**SUBJECT:** **CHANGE ORDER #2 TO MATRIX HG INC. FOR THE  
FAIRFIELD CAMPUS CENTRAL PLANT REPLACEMENT  
PROJECT**

**Change Order #** 002  
**Project No.:** 23-005  
**Date:** 7/17/2024

**Project:** Solano Community College District  
Fairfield Campus  
**CENTRAL PLANT REPLACEMENT PROJECT**

Solano Community College Central Plant Modernization  
Matrix Job #230477  
**CHANGE ORDER PROPOSAL SUMMARY SHEET**

SBSCC.MAG.1016

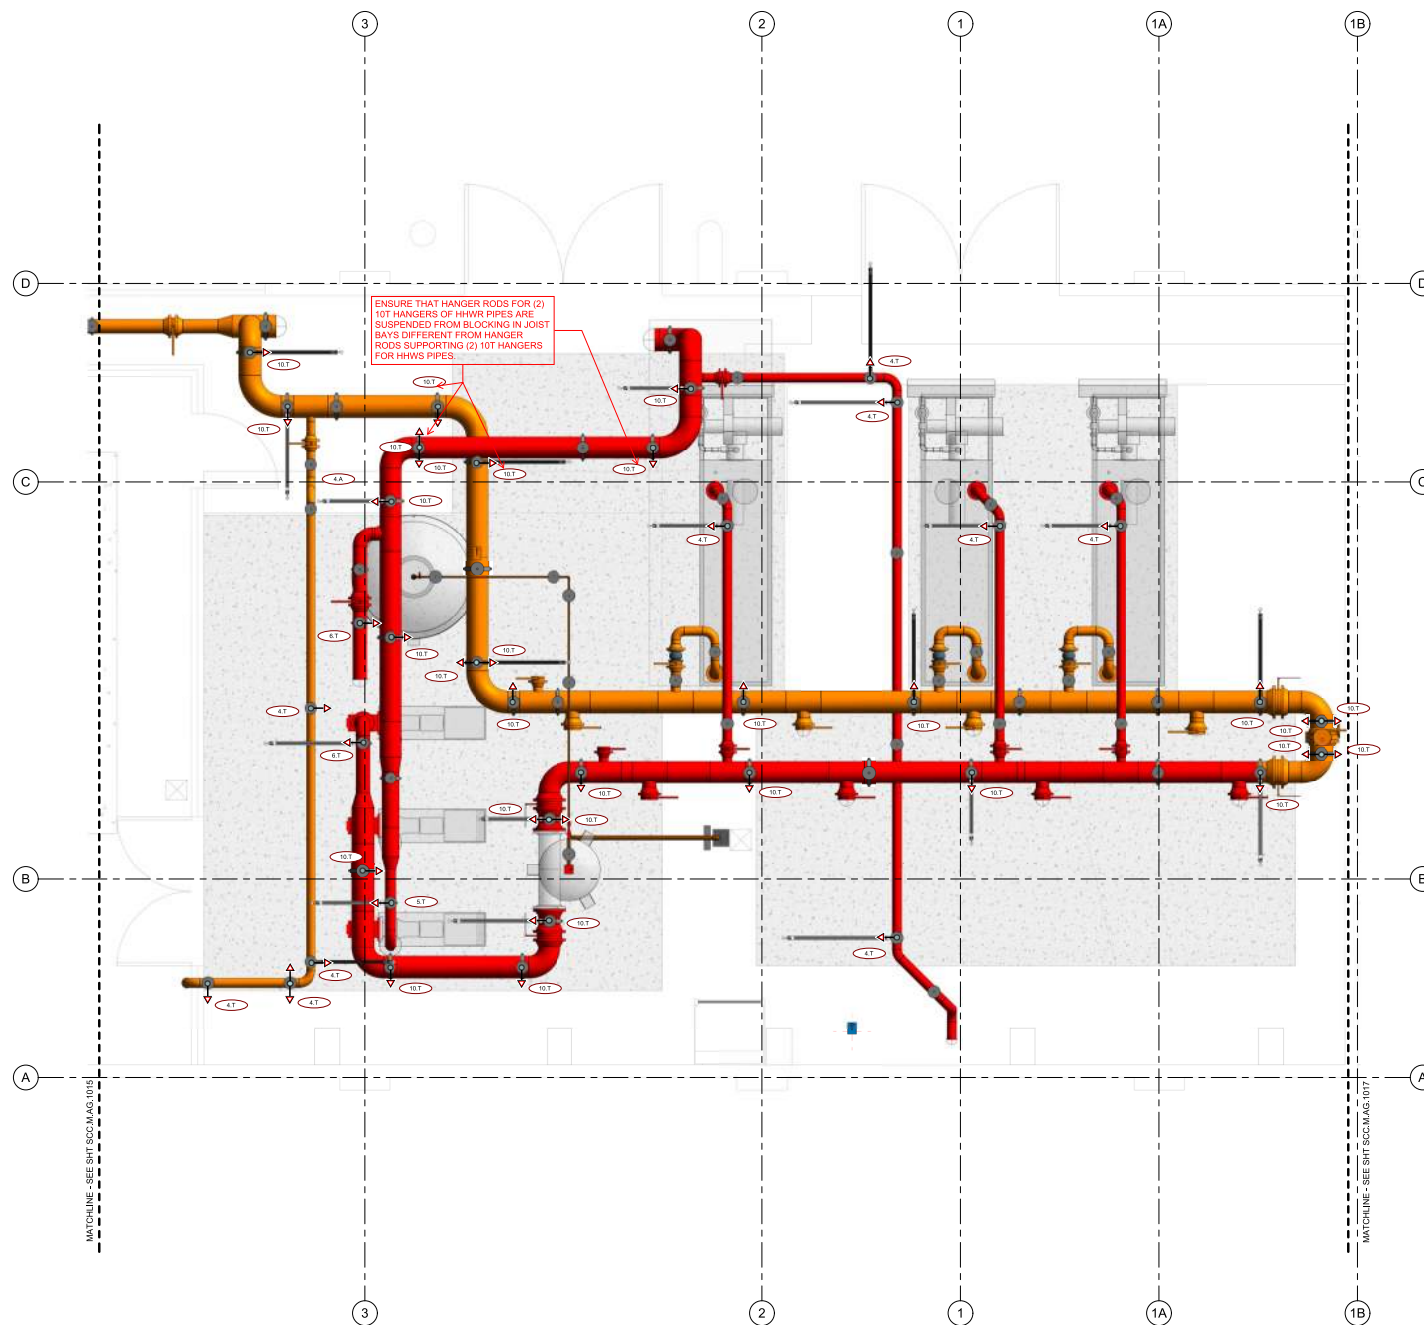
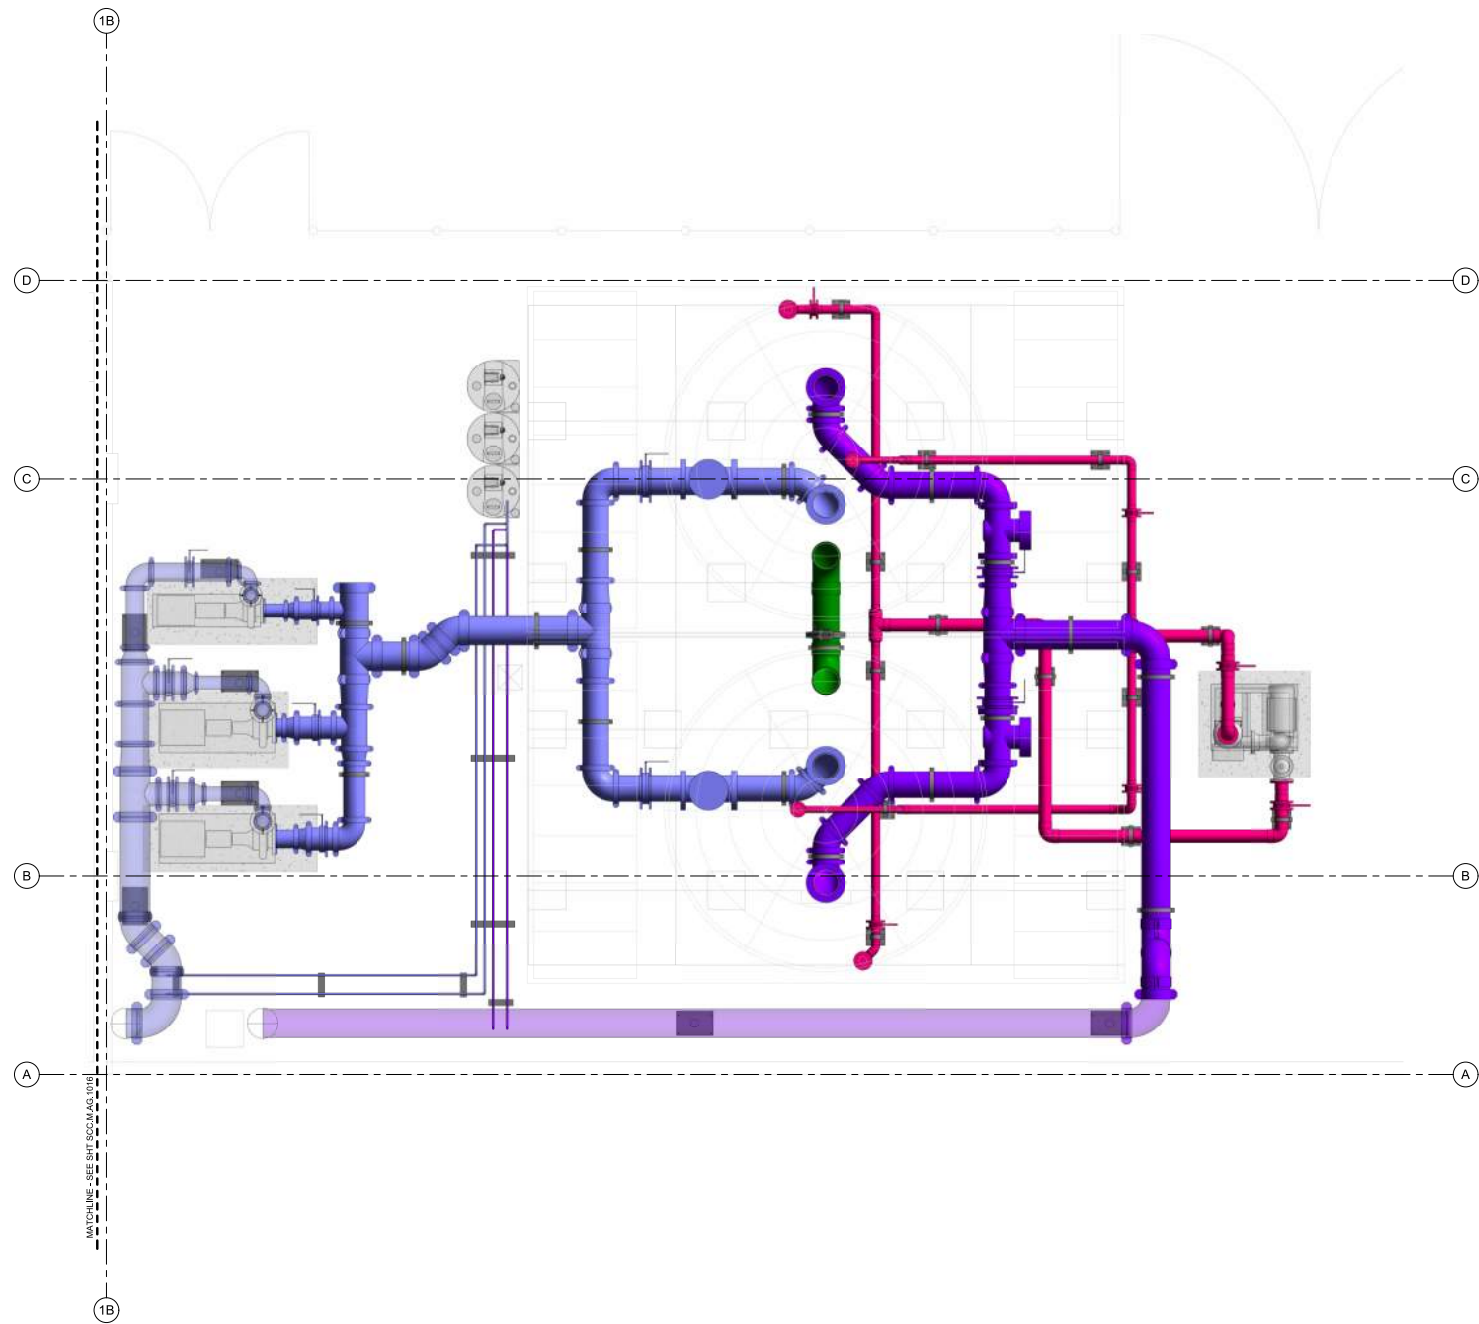
The original drawing M1.2.2 located hangers and seismic bracing with is what our bid was based on. Thru the submittal and RFI process, further evaluation of the weights of the utilities, along with the capacity of the existing wood members, caused the need to add to the qty of both hangers and brace arms. The addition of the support members raised concern against joist loading which ultimately caused CCD 4 to be generated which added new tube steel between HSS and added sistered joists.

SHEET TITLE  
STRUCTURAL  
CHILLER AND BOILER FLOOR PLAN

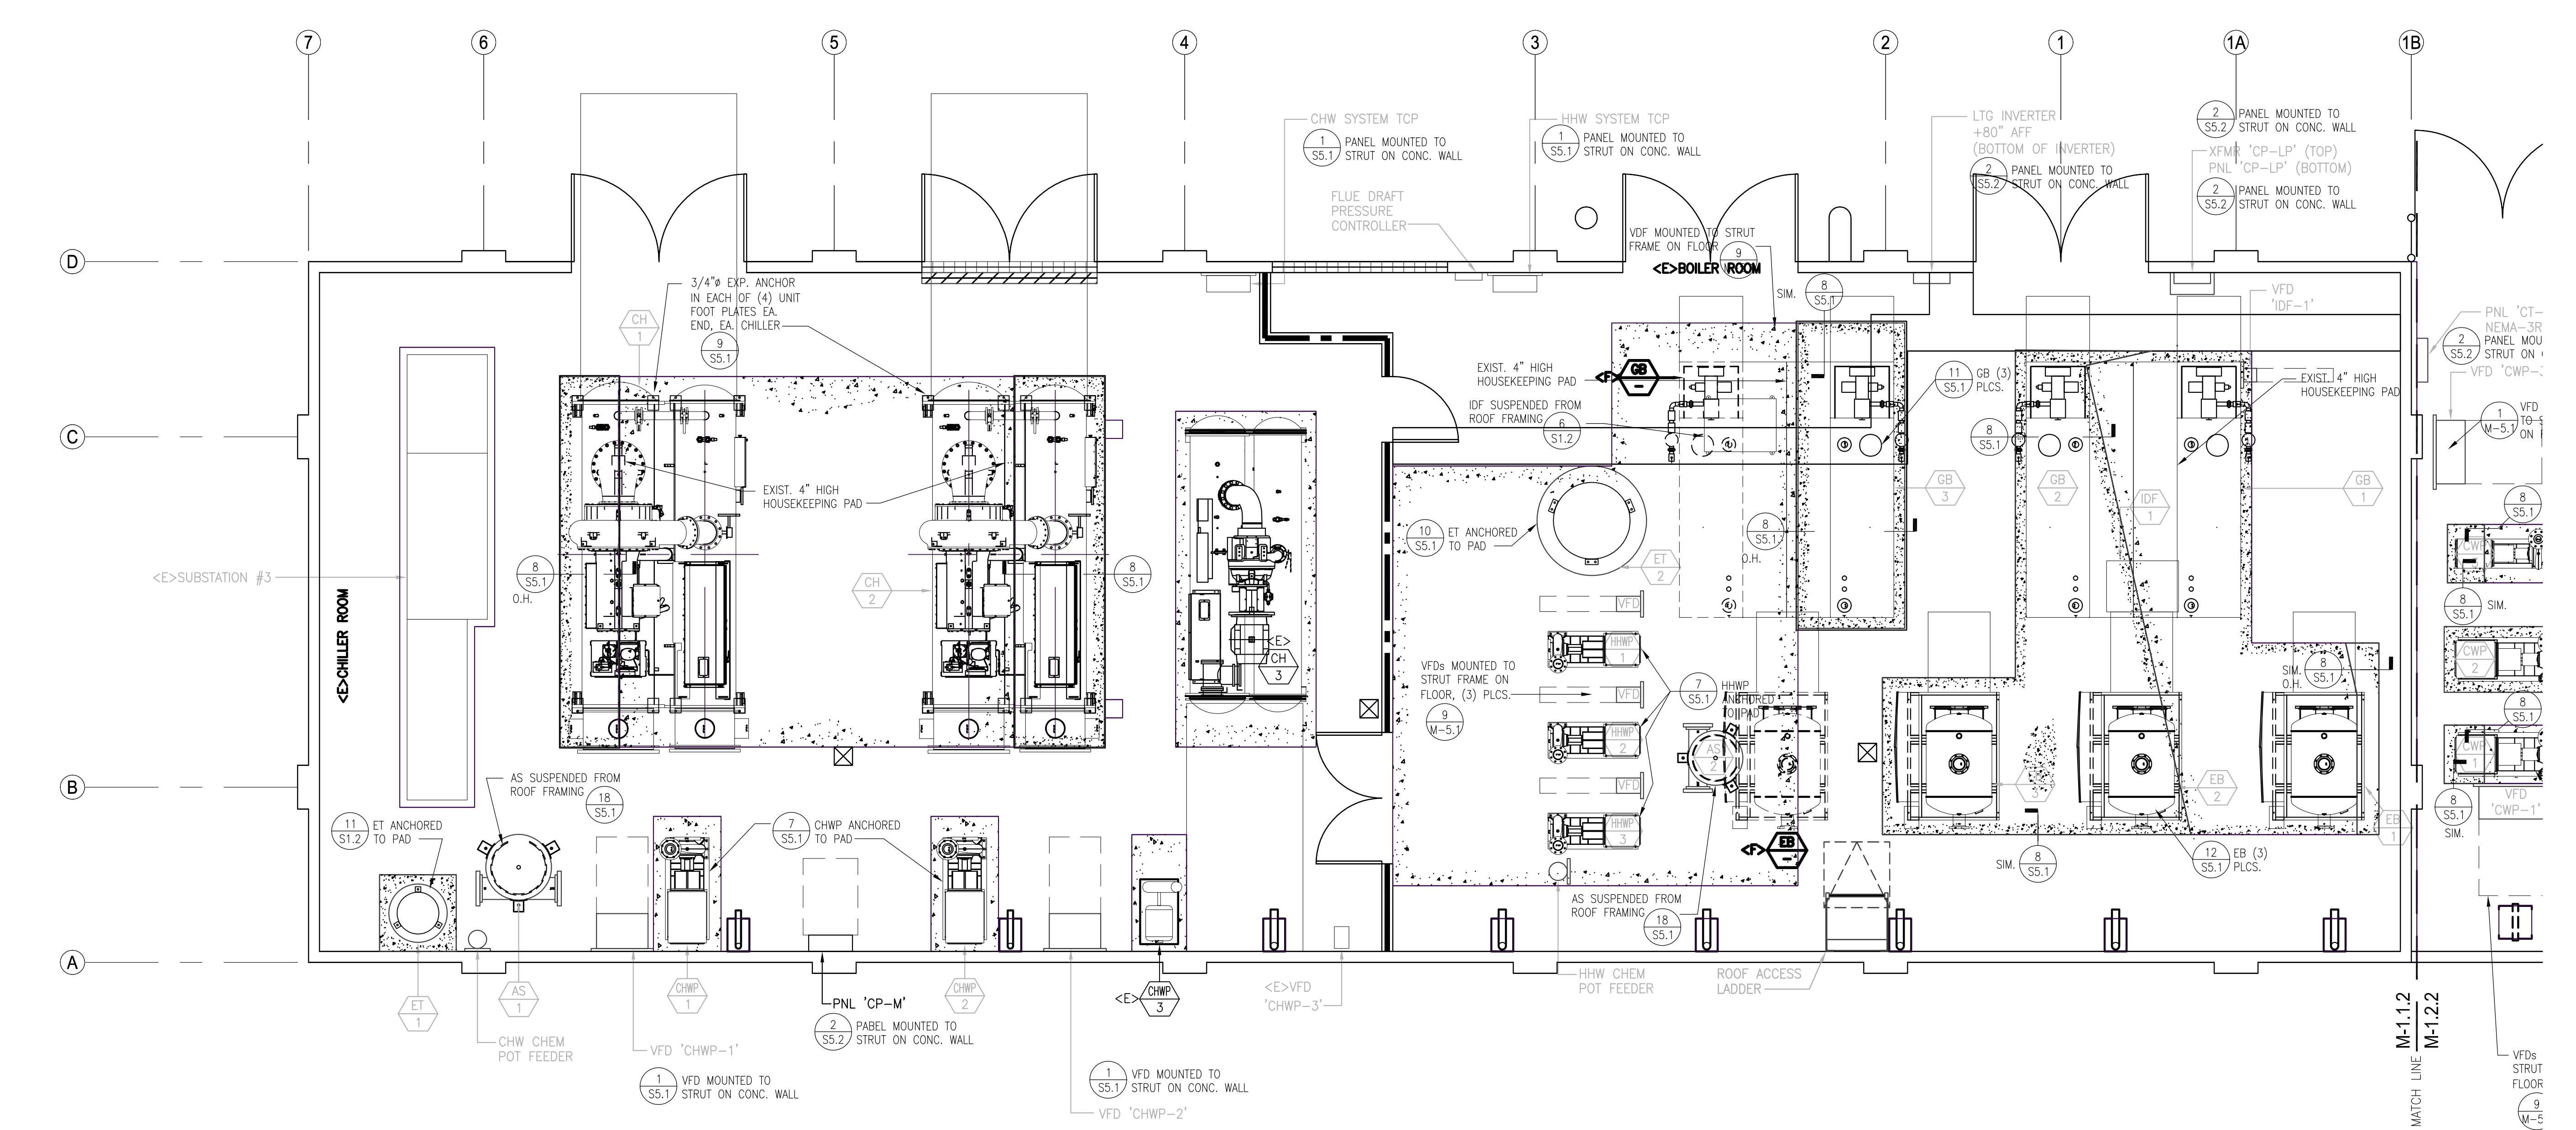
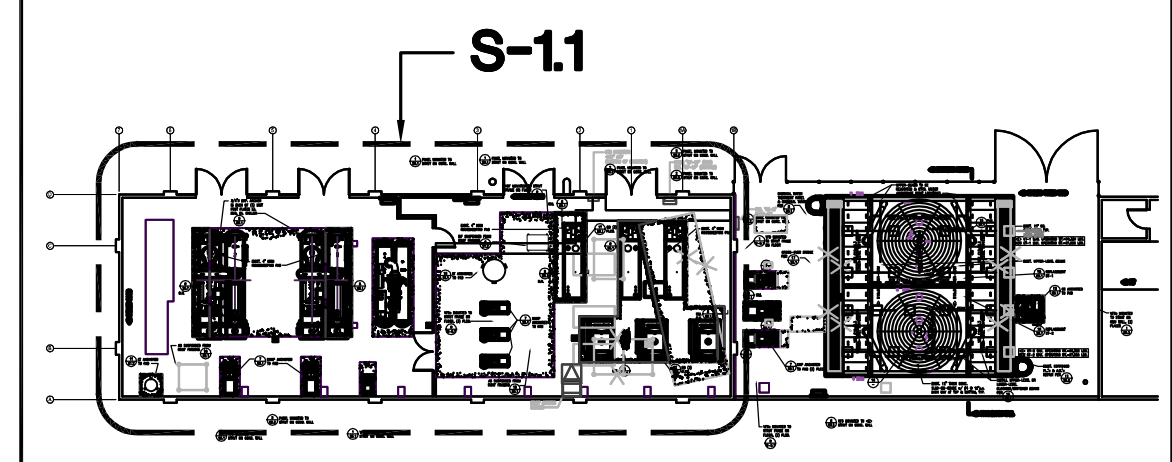
008.2 CCD #4 resulted in the need for additional supports and structural elements to properly distribute loads onto the building structure. This change order includes all costs associated with this CCD. All labor, materials, and equipment needed to complete this work is included.
